ALAMEDA COUNTY
HEALTH CARE SERVICES

December 11, 2007

Subject: Fuel Leak Case No. RO0002585 and Geotracker Global ID T0600186816, Wente Winery, 5565 Tesla Road, Livermore, CA 94550

Attachment
Revised Figure 2

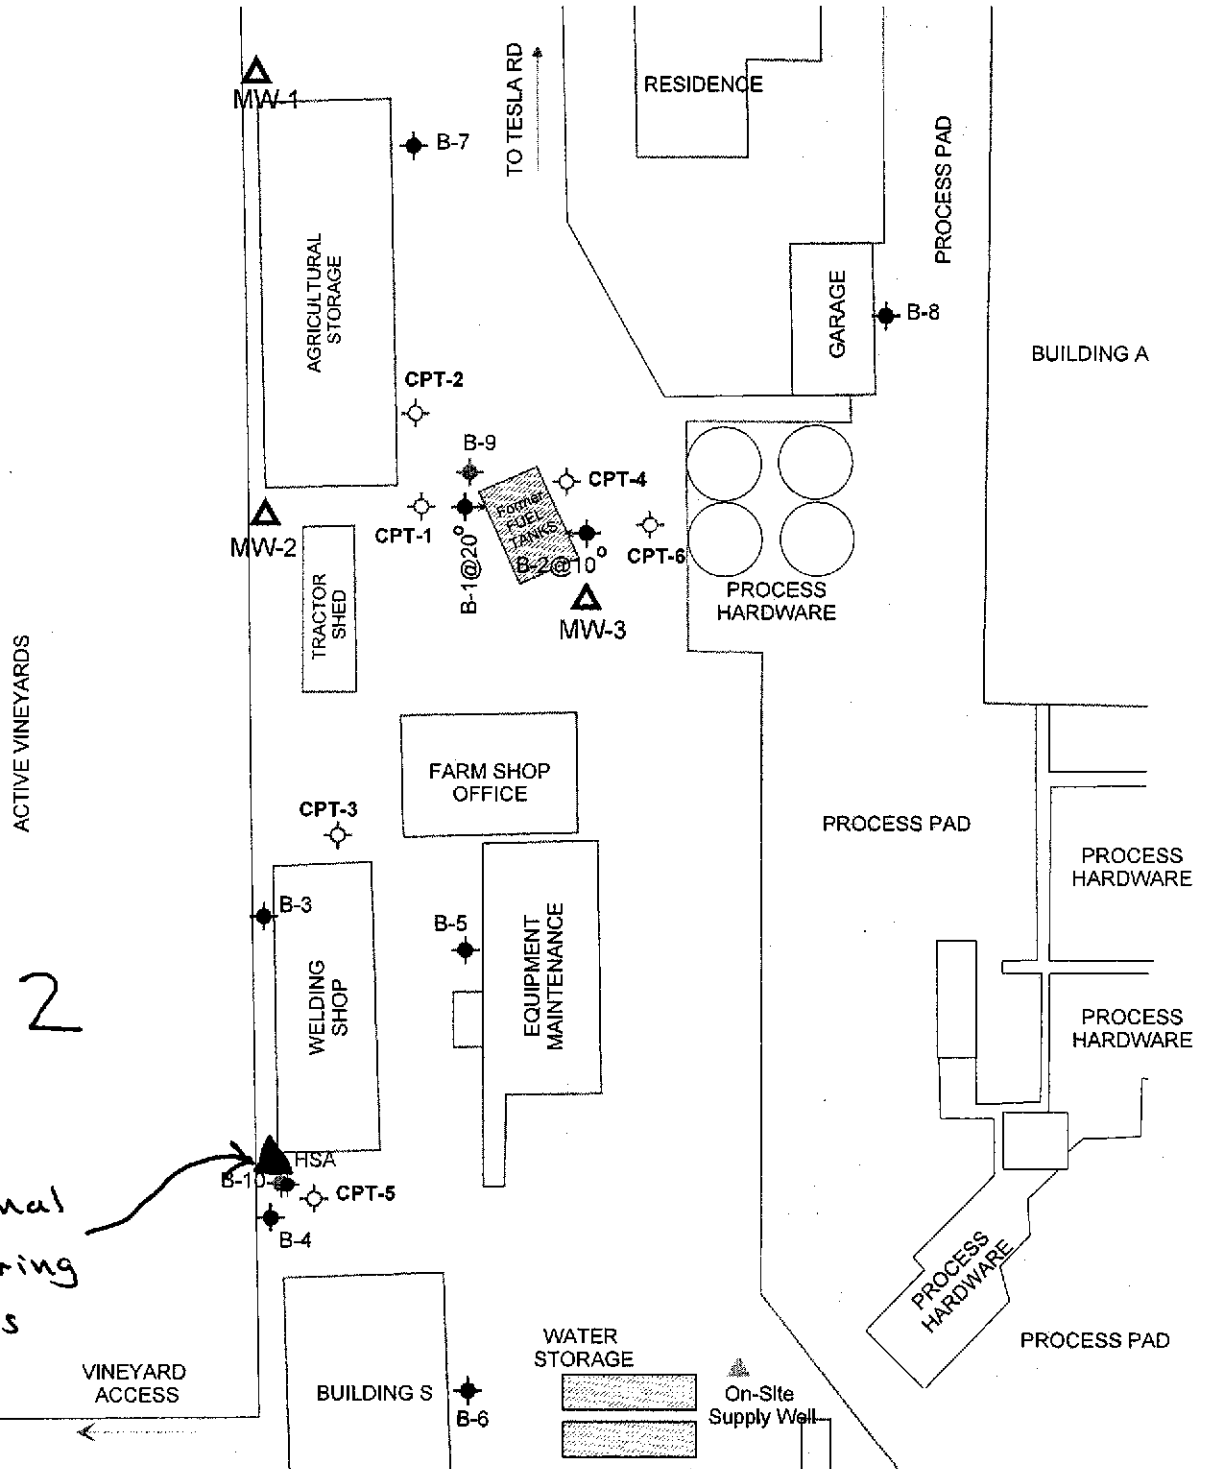
1. **Monitoring Well Installation.** The proposed methods for well installation are acceptable. We request that the location of the proposed monitoring well south of the Welding Shop be moved further west as shown on the attached Revised Figure 4. Due to the sporadic detections of chloroethane, chloromethane, tetrahydrofuran, and elevated concentrations of metals in groundwater from the off-site supply well, we request that one groundwater monitoring well also be installed directly upgradient of the off-site water supply well as shown on attached Revised Figure 2. The purpose of this well is to sample shallow groundwater in the area of the off-site water supply well to help evaluate the sporadic detections of volatile organic compounds and metals in water from the off-site supply well. The two additional monitoring wells are to be sampled no sooner than 48 hours after development. Please see technical comment 4 below regarding groundwater analyses. Please present the well installation and sampling results in the Monitoring Well Installation and Sampling Report requested below.

Revised Hand Auger and Depth-discrete Groundwater Sampling Locations Figure

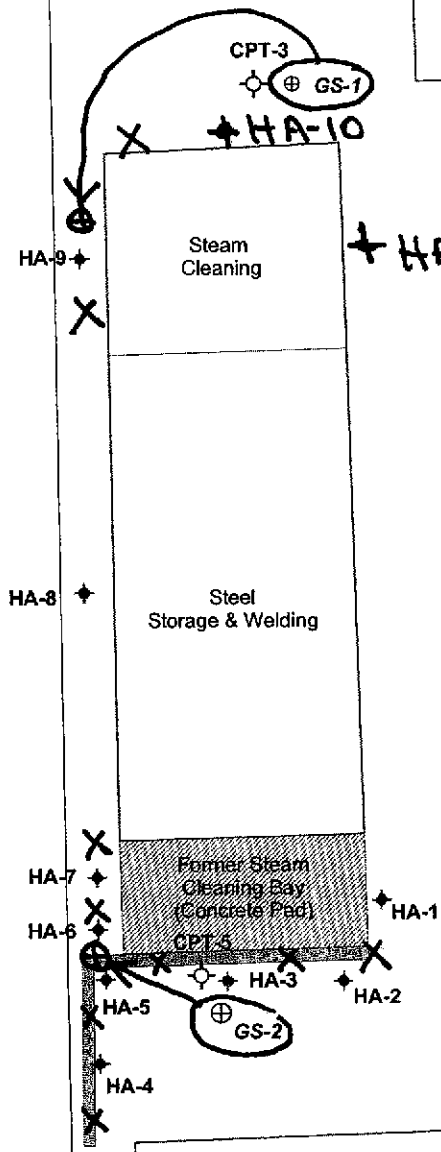
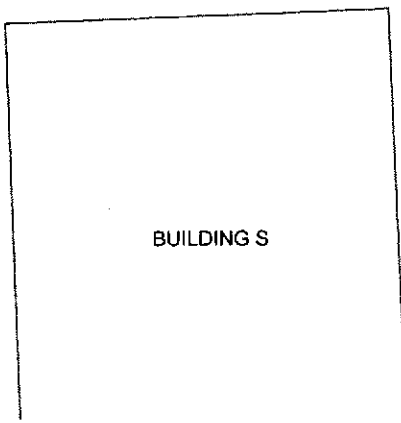
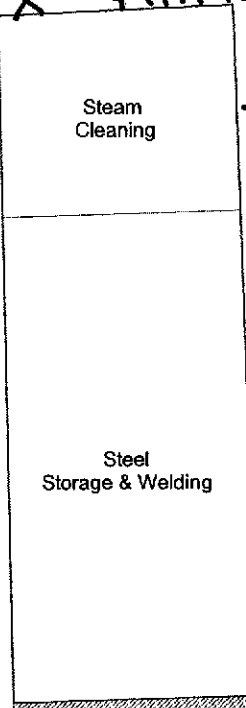
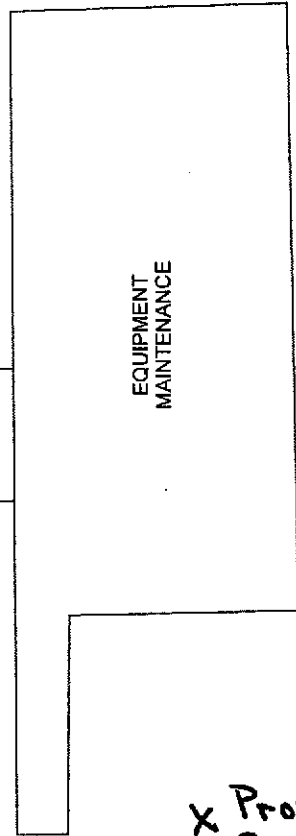
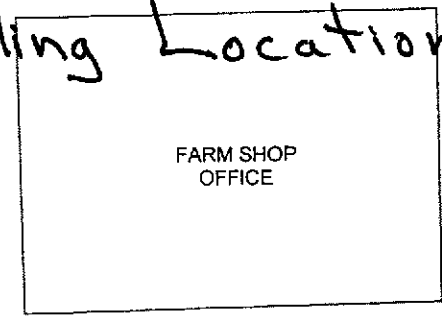
1. **Proposed Depth-discrete Groundwater Sampling from GS-1.** The Response to Comments/Work Plan proposes the collection of grab groundwater samples from intervals of 11 to 16 and 39 to 44 feet bgs at proposed location GS-1. We also request that a grab groundwater sample be collected from a depth of 58 to 63 feet bgs at proposed location GS-1. We request that proposed location GS-1 be moved to a location downgradient from the Steam Cleaning Area as shown on the attached "Revised Hand Auger and Depth-discrete Groundwater Sampling Locations Figure."

2. **Proposed Grab Groundwater Sampling from GS-2.** The Response to Comments/Work Plan proposes the collection of grab groundwater samples from intervals of 19 to 24 and 56 to 61 feet bgs at location GS-2. We concur with the proposed depth intervals for the depth-discrete grab groundwater sampling in GS-2. We request that proposed location GS-2 be moved to a location downgradient from the former unlined drainage ditch and Steam Cleaning Bay as shown on the attached "Revised Hand Auger and Depth-discrete Groundwater Sampling Locations Figure."
